PROJECT: OUSD MIRA MONTE FIELD RENOVATION
RE: Bid RFI Response
DATE: May 20th, 2021

RFI Emails 1 & 2 - Sam Bennett with Summer Construction

RFI 05-19-21 from Chris Ngo with Marina Landscape, Inc.

AQUA-FLO SUPPLY		
MIRA MONTE SCH.		
DESIGNED BY: EILEEN FAY LABER		
SCALE : 1"=40'	DATE : 2.18.85	TURF

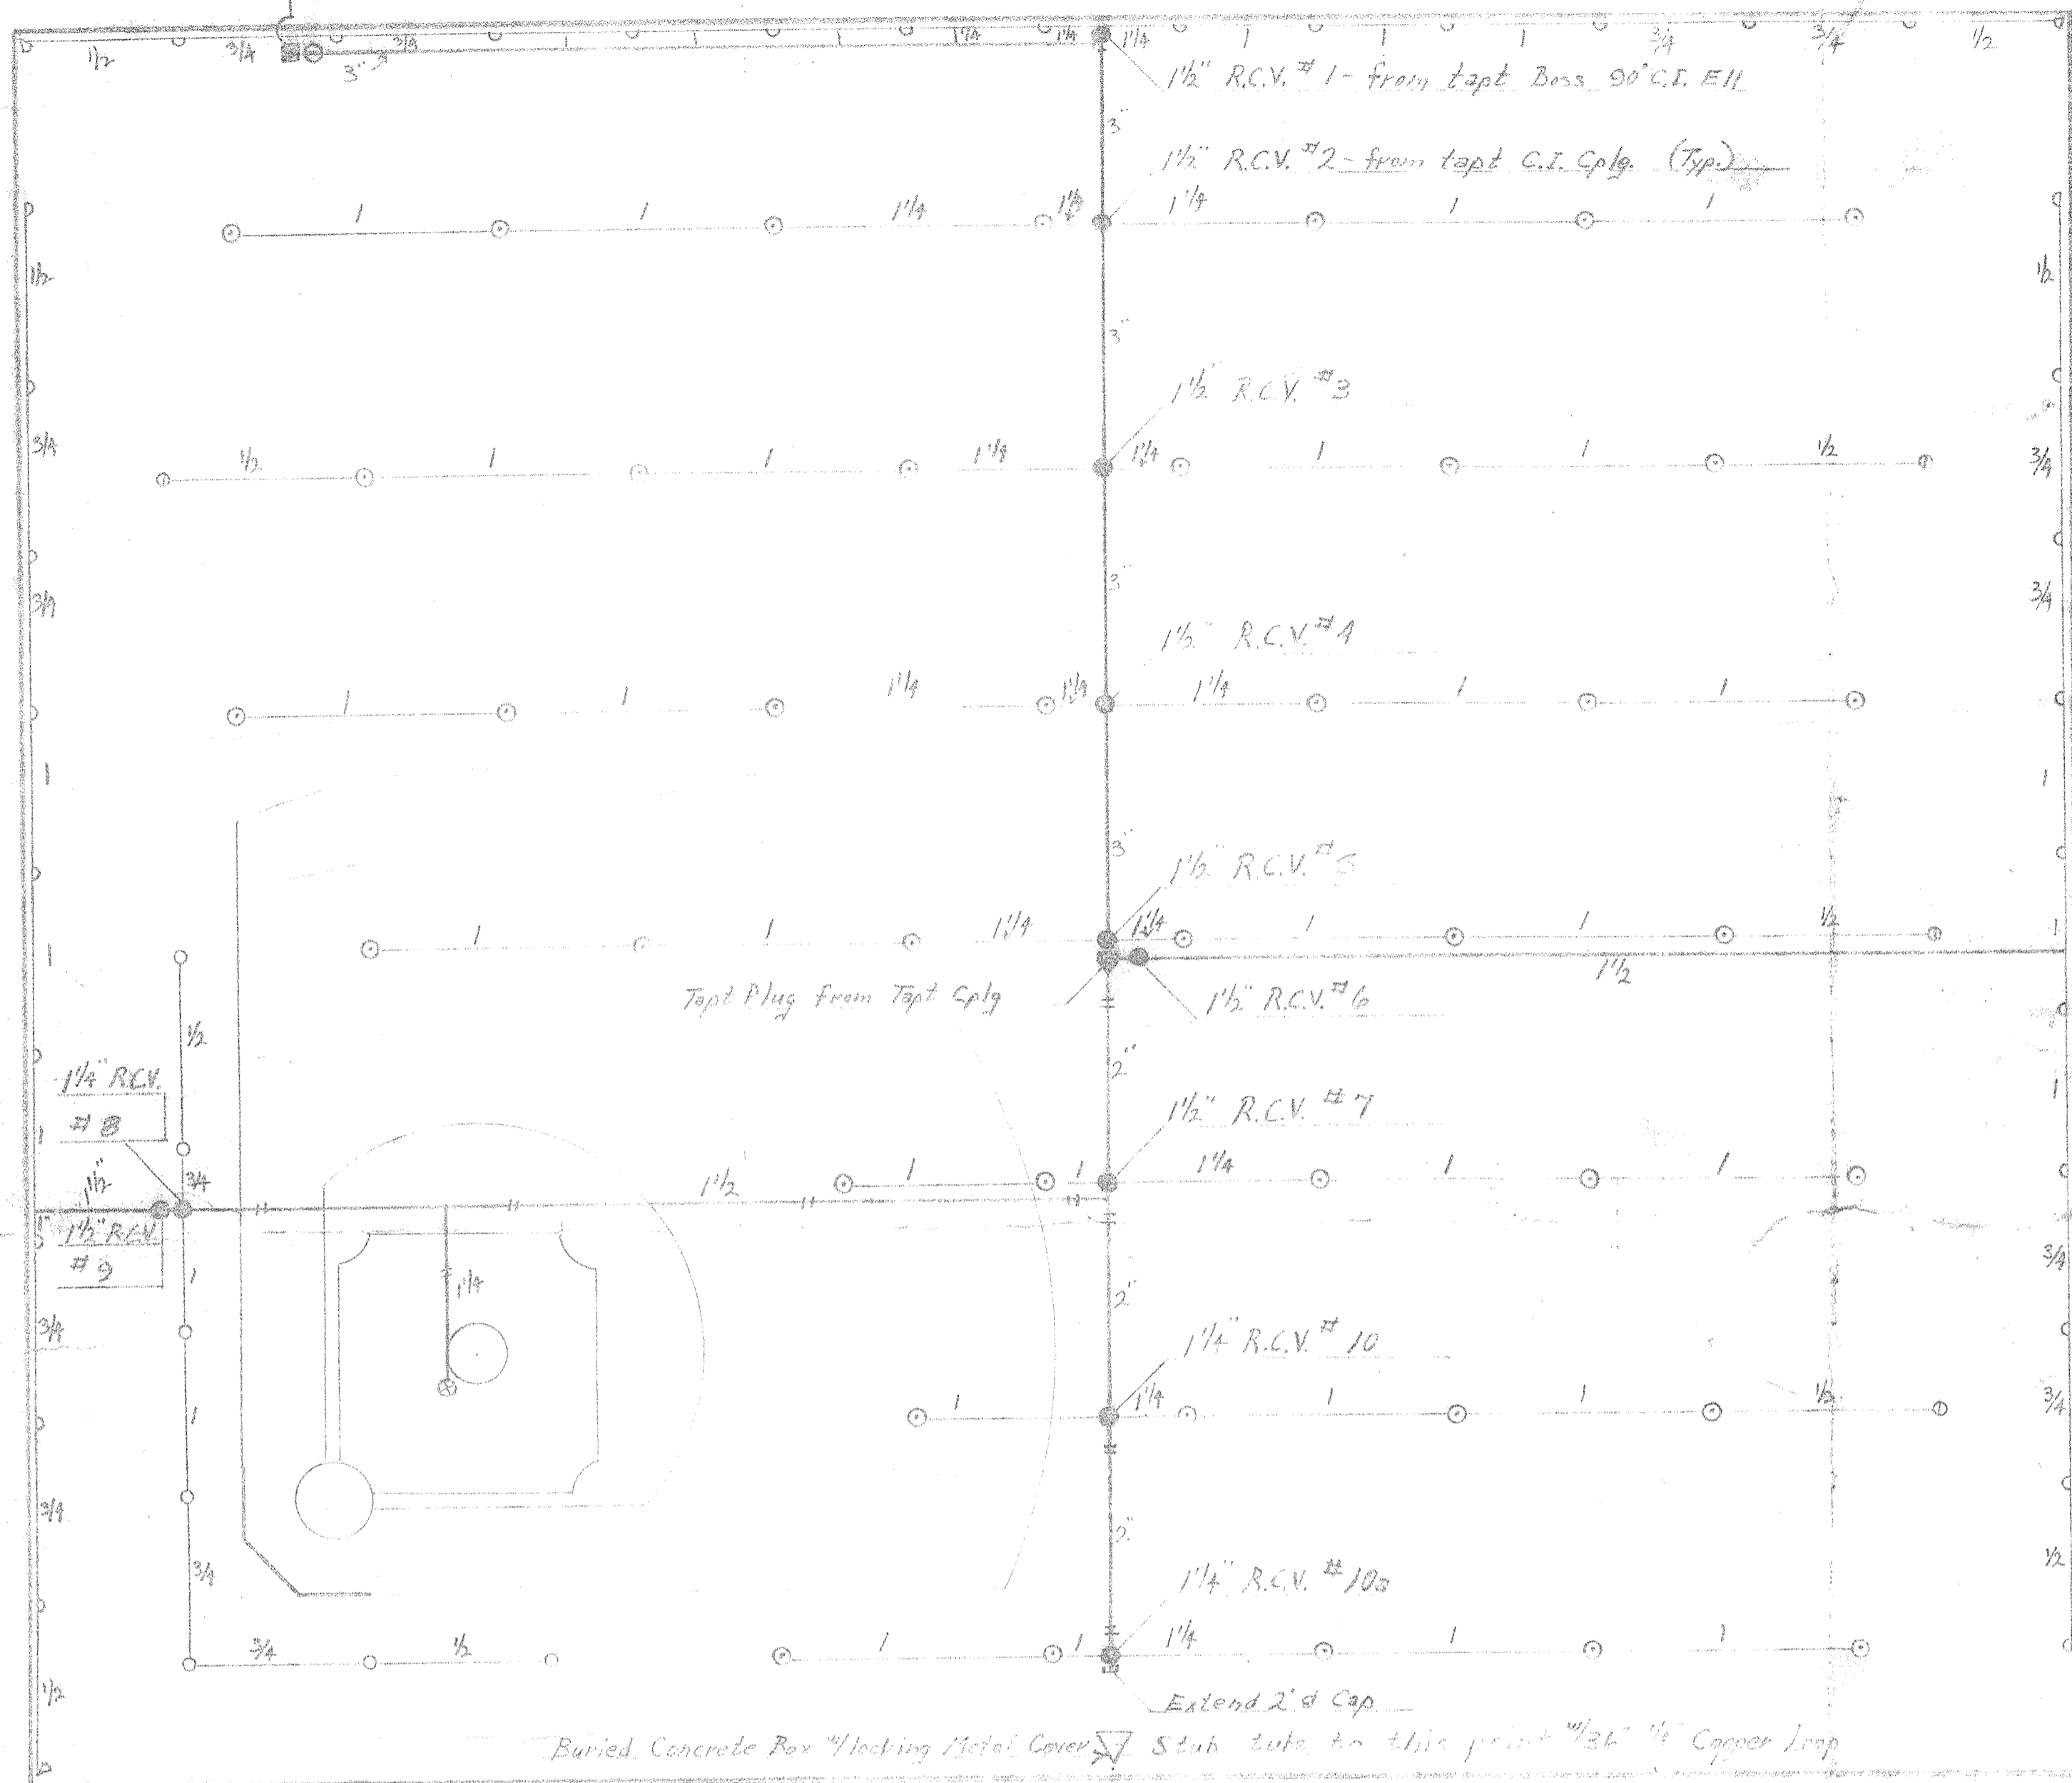
1. *Please provide as built irrigation plans.*
 - a. Please see attached As-Built Irrigation Plans
2. *Please provide the thicknesses and material type of existing paving that is to be removed. In addition, any known reinforcements.*
